NOVI PLAZA FACADE JSP 15-40

Approval at the request of Scott Monchnik & Associates for Preliminary Site Plan and Section 9 Façade Waiver. The subject property is located in Section 26, south of Ten Mile Road and west of Meadowbrook Road, in the B-1, Local Business District. The subject property is approximately 1.6 acres and the applicant is proposing to remodel the existing façade for Novi plaza shopping center along with modifications to the existing parking lot.

PLAN REVIEW CENTER REPORT
June 02, 2015
Planning Review: Preliminary Site Plan
Novi Plaza Facade
JSP 15-40

SITE PLAN
 1" = 20'-0"

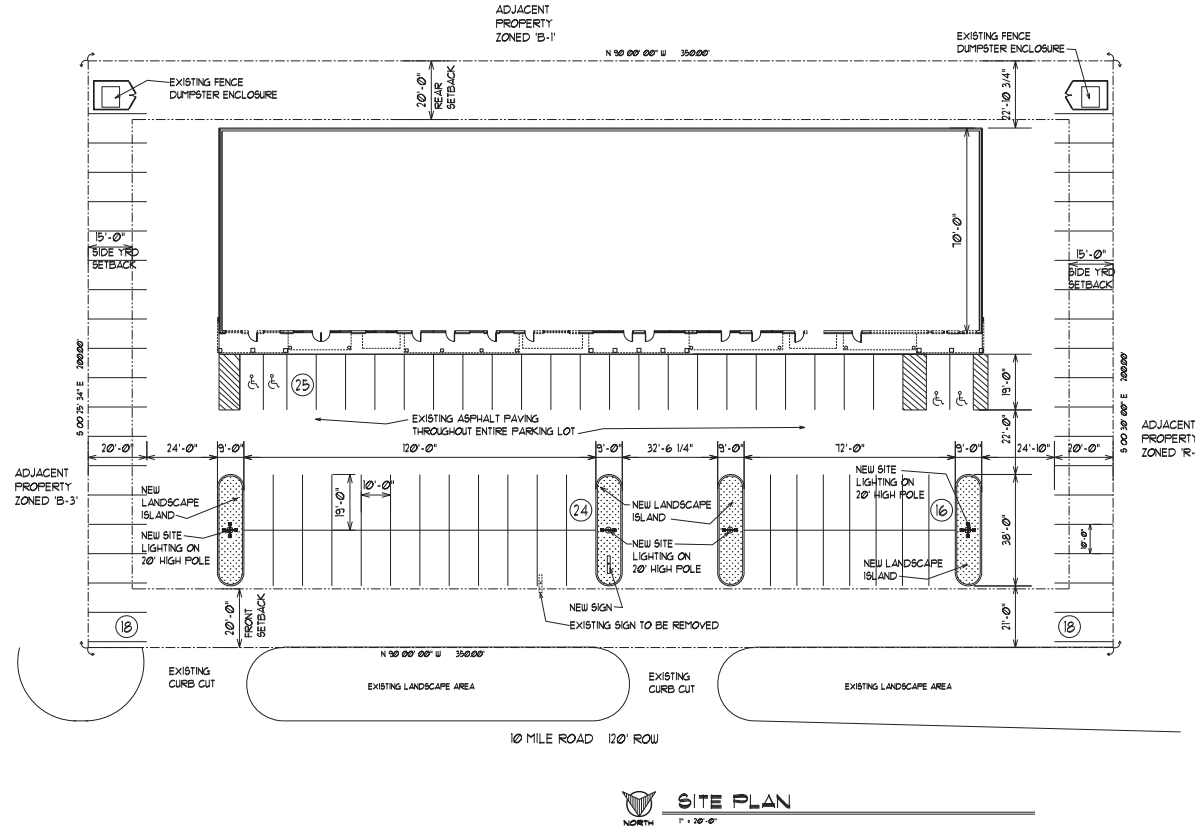
1. **Barrier Free Parking**: According to Barrier Free code, for a total 101 to 150, 4 barrier free parking & 1 van barrier free parking spaces are required. **Building data on current site plan refers to 4 proposed barrier free parking spaces. One of the barrier free spaces on west**

end of the building does not have an access aisle. Revise and propose the minimum required spaces. Proposed building columns are conflicting with the barrier free aisle locations. Please revise to avoid the conflict.

2. **Barrier Free Signs:** One sign for each accessible parking space is required. **Propose the required barrier free signage according to the code**
3. **Bicycle parking (Sec 5.16):** **For the proposed use, five (5) percent of required automobile parking, 2 spaces minimum are required. Please provide the minimum required along with the details and lot layout according to section 5.16**

1. **Based on the vehicular use areas, approximately 10 canopy trees would be required within the parking area. Instead we ask that the applicant plant seven (7) canopy trees within the new landscape islands (2 per island except for the island with the relocated sign).**
2. **The islands should have a lawn groundcover, not rock or mulch.**

1. New islands in the parking lot impede apparatus turning radius. Fire apparatus access drives to and from buildings through parking lots shall have a minimum fifty (50) feet outside turning radius and designed to support a minimum of thirty-five (35) tons. ***(D.C.S. Sec 11-239(b)(5))***

- 1) **Recommended for approval with the correction of the above.**
Adjust islands to allow for 50' outside turning radius, apparatus cannot enter the site off Ten Mile Rd. and proceed to the front of the building.

-we will revise the barrier free parking locations and quantities; we will provide bicycle parking; add B-1 District notes for required conditions; provide lighting photometric plan; provide economic impact letter.

we will provide the requested trees and landscaping.

We will rework island radius, to allow for fire apparatus access.

PROPOSED LEFT SIDE ELEVATION

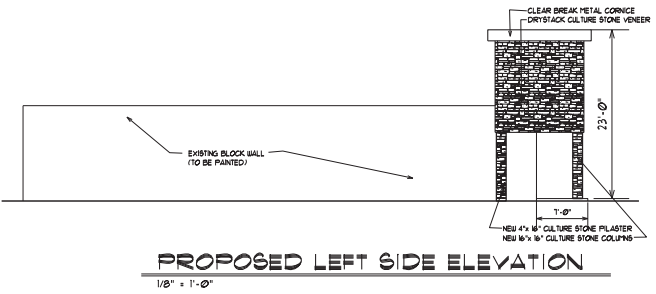
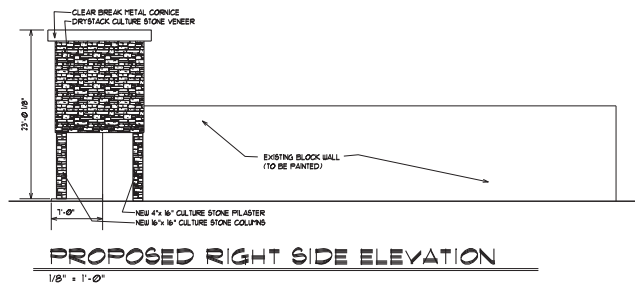
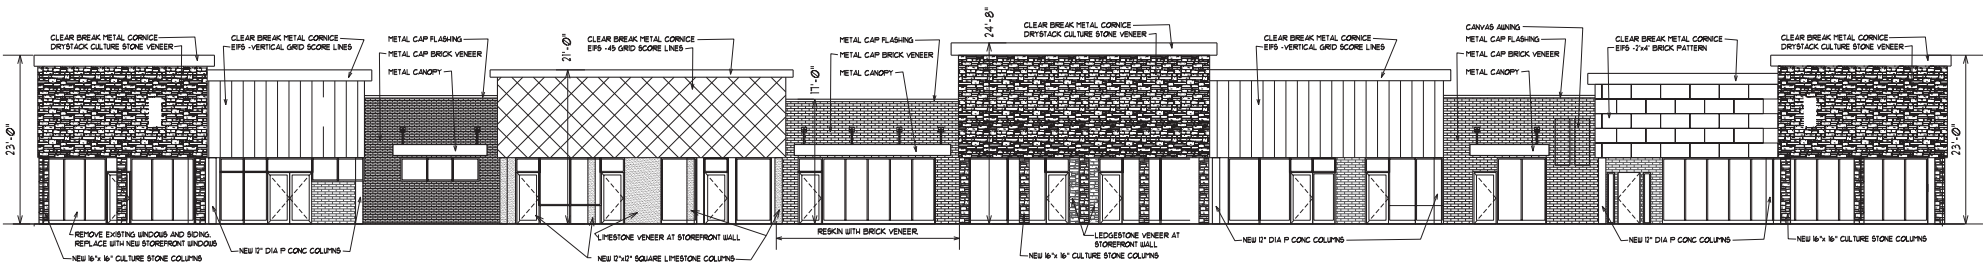
North (Front)	West (Right)	East (Left)	South (Rear)	Ordinance Maximum (Minimum)
BRICK	32%	0%	0%	Unaltered	100% (30%)
CULTURED STONE	26%	10%	10%	Unaltered	50%
EIFS	32%	0%	0%	Unaltered	25%
FLAT METAL (CORNICHE)	10%	0%	0%	Unaltered	50%
PAINTED CMU (EXISTING)	0%	90%	90%	Unaltered	0%

Comments: This application consists of façade alterations in accordance with Section 5.15.6 of the Ordinance. This Section states that when new materials are proposed for an existing facade, the entire facade shall be brought into compliance unless horizontal offsets greater than 2’ occur separating the altered and unaltered areas. The Ordinance does not require the alteration of all facades when one or more facades are proposed to be altered. Therefore, the south (rear) façade is in technical compliance with the Façade Ordinance. The plans indicate that an offset is provided between the altered and unaltered portions of the east and west facades. Although the offset is less than 2’ the intent of the Ordinance has been met with respect to visually separation of the altered and unaltered portions of these facades. Therefore, the side facades are also in technical compliance with the Ordinance with respect to materials.

Section 5.15.3 of the Ordinance requires that roof appurtenances be screened from view with materials consistent with the building design. Numerous roof appurtenances are currently visible on the building. It appears that these will be adequately screened via the raised parapets proposed on the north façade. This will significantly increase the appearance of the building. However, as shown in the photograph below, the roof appurtenances are also visible on the west (and east) façade. It is recommended that the applicant consider adding similar parapet extensions or other screening devices to screen these roof appurtenances, particularly on the west facade.

Recommendation: As shown in the chart above, the proposed percentage of EIFS on the north façade exceeds the maximum amount allowed by the Façade Ordinance (32% vs. 25%). A Section 9 Waiver is required for this deviation. It is our recommendation that the proposed alteration will significantly improve the overall appearance of the building and is consistent with the intent and purpose of the Façade Ordinance. *A Section 9 Waiver is therefore recommended for the Overage of EIFS on the north facade.* It is strongly recommended that screening of roof appurtenances be provided on the side facades, particularly on the west facade.

We will review the west elevations, to provide additional screening for existing RTU's.
